Note to P802.3bn Editors/Task Force: the RxMER value to be stored per subcarrier needs to be an 8 bit unsigned integer with a value of 0 to 255. This value represents increments of 0.25 dB steps from 0 db (value 0x00) to 63.50 dB (value 0xFE). The value 0xFF is defined to mean that the RxMER cannot be measured for that subcarrier as explained in the text below. If this draft text is approved, this also includes the adding of an 8-bit RxMER value type or the modification of existing/anticipated RxMER value type per subcarrier). Also, need to modify receiving FFT function label in appropriate figures to include "Pilot Processing, Equalization, and FFT".

Note to P802.3bn Editors: This is a new subsection to be placed under CL 100, CNU receiver functional requirements. Suggest adding as a new subsection: 100.2.11.3 (replacing anything else that was there).

100.2.11.3 Receive modulation error ratio requirements

Figure 100.100-X-1 - Computation of Received Modulation Error Ratio (RxMER) for a given subcarrier

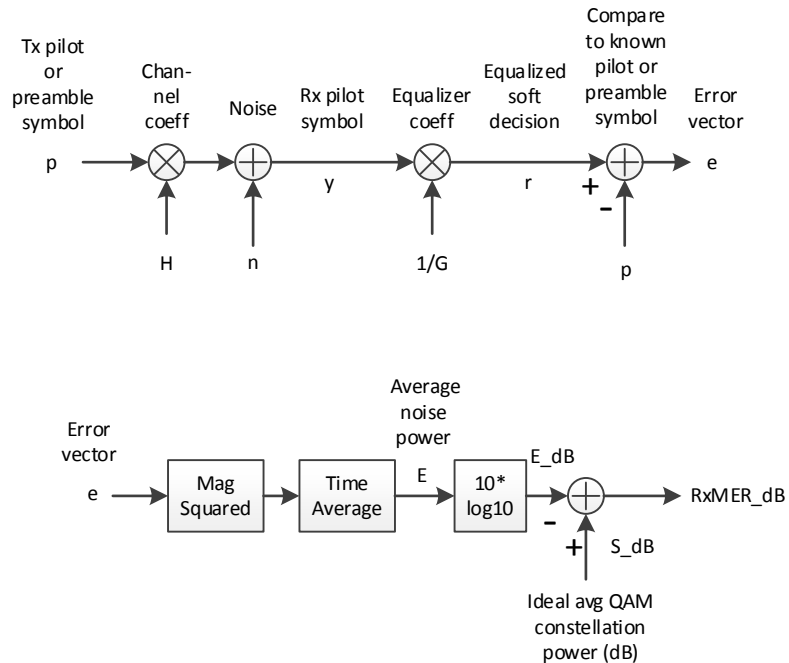
RxMER may be more clearly defined in mathematical notation in accordance with Figure 1009-X-1, which shows an ideal transmit and receive model, with no intent to imply an implementation. Let p represent the pilot or PHY Link preamble symbol before transmit IDFT, H presents the channel coefficient for a given subcarrier frequency, n represents noise, $y = H*p + n$ is the unequalized received symbol after receive FFT. The receiver computes G as an estimate of H , and computes the equalized received symbol as $r = y / G$. Using the known modulation value of the pilot or preamble symbol p , the receiver computes the equalized error vector as $e = r - p$. All the above quantities are complex scalars for a given subcarrier. To compute RxMER, the receiver computes E as the time average of $|e|^2$ (squared absolute value) over many visits of the pilot to the given subcarrier (or PHY Link preamble symbol as applicable), and $E_{dB} = 10*\log_{10}(E)$. Let S_{dB} be the average power of the ideal QAM data subcarrier constellation (not including pilots) expressed in dB. The CNU reports $RxMER_{dB} = S_{dB} - E_{dB}$. The CNU shall be capable of providing measurements of RxMER for all active subcarrier locations for each OFDM downstream channel, using pilots and PHY Link preamble symbols.
